### Re: The proposed redevelopment of 1 Triton Square and St Anne's – Daylight, Sunlight and Overshadowing Supplementary information

GIA have been requested by the London Borough of Camden to provide additional information in relation to the technical reports submitted on behalf of the above development sites (planning ref:2016/6069/P). This information relates to the daylight and sunlight and overshadowing reports dated 21/10/16.

**Fig 01 – Street View of 4 Laxton Place**

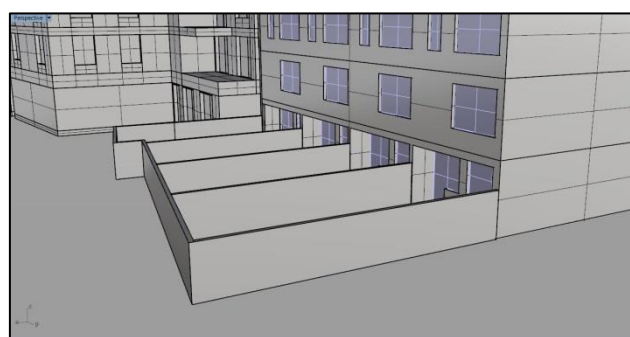
The overshadowing analysis carried out by GIA in our aforementioned report had considered the rear gardens of 1-4 Laxton Place as a single amenity space. GIA have been requested to run an additional Sun Hours On Ground ("SHOG") analysis which isolates the impact upon the garden at 4 Laxton Place only. In the absence of any clear aerial imagery, GIA have carried out this SHOG analysis assuming that a defined boundary exists between the rear private amenity spaces of 3 and 4 Laxton Place (see figure 01 and 02 below).

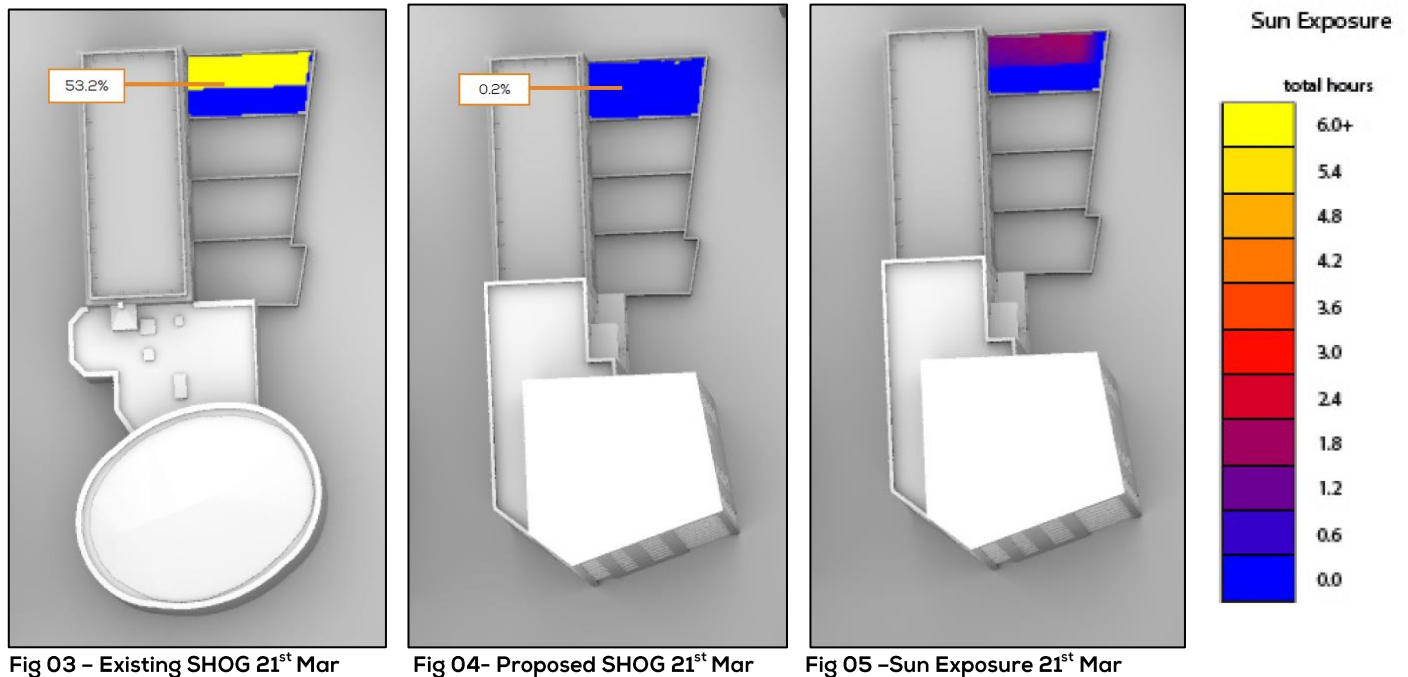
In the existing scenario, our analysis demonstrates that on the 21st March (figure 03), the garden space at 4 Laxton Place will marginally adhere to BRE guidance with 53.2% of the area enjoying 2+ hours of sunlight (against a 50% target value). It is worth noting that the remaining 46.8% of the area is already overshadowed by the existing boundary divide.

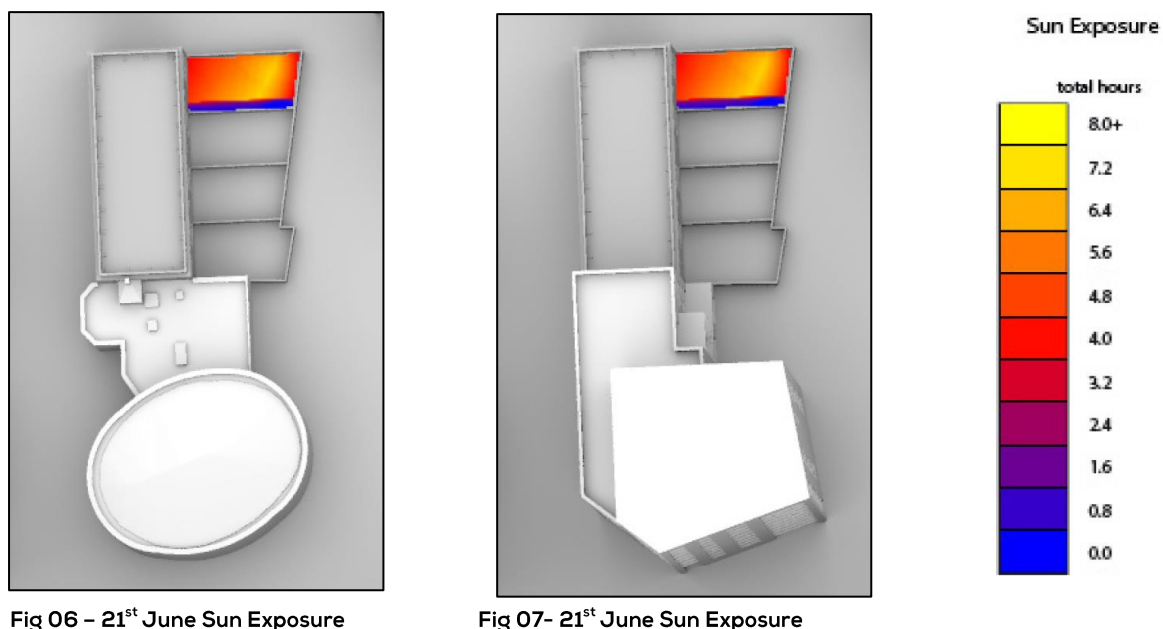
In the proposed scenario, the area enjoying direct sunlight will reduce to 0.2% (figure 04). Notwithstanding the above, the results from the sun exposure assessment illustrate that almost half of the area will continue to enjoy almost 1.8 hours of direct sun on the 21st of March (figure 05), which is marginally below BRE guidance and can in part be attributable to the inner city environment of which this amenity space is located. The majority of the area which does not meet this criterion is located within the 46.8% of the garden which is already in shadow.

GIA are of the opinion that in addition to the assessment of the 21st of March, it is also relevant to understand the level of sunlight achieved on the summer solstice (21st June). Our detailed analysis illustrates that there are de minimis alteration in sunlight enjoyment when comparing the existing v proposed results and that up to 7.2 hours of sunlight will be experienced at a time when the space is most likely to be used.
